PRELIMINARY IMPACT ANALYSIS

This proposal seeks to review Joint Australian New Zealand Standard (AS/NZS) 3500, *Plumbing and drainage Part 2: Sanitary plumbing and drainage* to amend the requirements for connecting of drains installed at grade.

Responsible Technical committee: Australian Standard Committee WS-014, *Plumbing and Drainage*

The image above shows the waste blockage/stranding at the 45 degree junction and up into the branch line in the standard test configuration

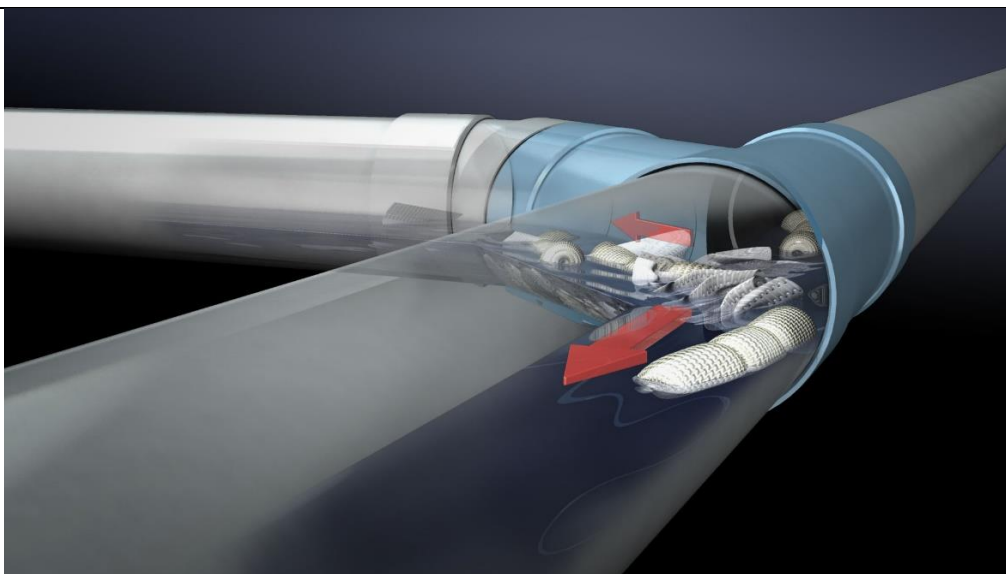
Test results showed the 4.5L full flush discharge from the toilets performance was adversely affected by each 45-degree junction. During a full flush discharge, the water was found to travel up each of the four branch lines significantly reducing the flush volume carrying the waste test media, stranding the solids and paper. Standing was also observed within the 45-degree junction caused by the redirection of the flow of the waste from the junction, refer to the link and images below.

To determine an appropriate solution, a number of alternative 45-degree junction configuration were tested. One possible solution that was tested was a configuration utilized by the German Standard, DIN 1986. DIN 1986 requires 45-degree junctions to be installed at a minimum of 15 degrees inclination when connecting a main drain to a branch drain.

This configuration was evaluated through physical testing and observations found this to provide the best performance of all alternative configurations tested. The configuration resolved all issues experienced and the following improvements in performance observed:

The graphic image above shows the redirection of the flush discharge and waste as it travels down the drain line and into the 45 degree junction connection area

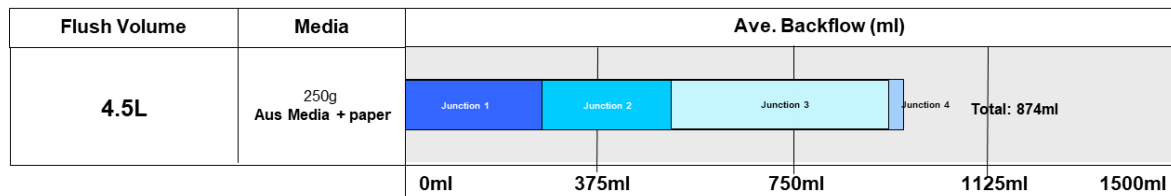
Testing showed that the wastewater flowed through each of the 45-degree junctions into the branch lines. Results were measured from each junction and the water loss totalled 874 ml or a 19% loss of the original 4.5L full flush volume discharged from the Water Closet.

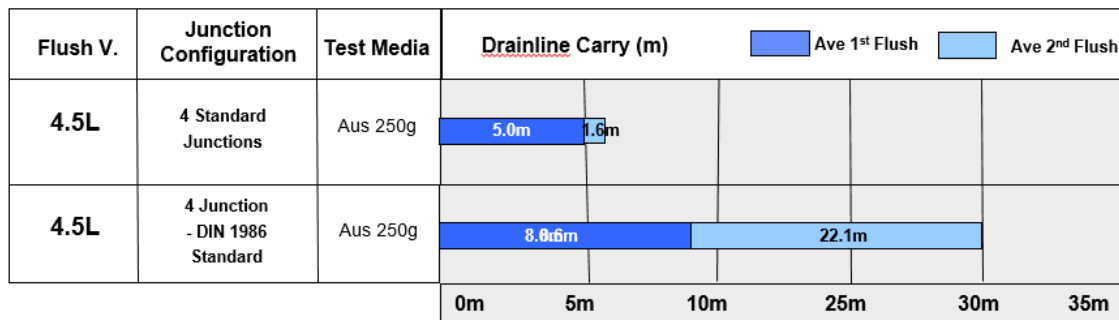
The average sanitary drainage transportation distance of solid and paper test media achieved was 5 metres after a single flush and 6 metres after two flush discharges (see below results).
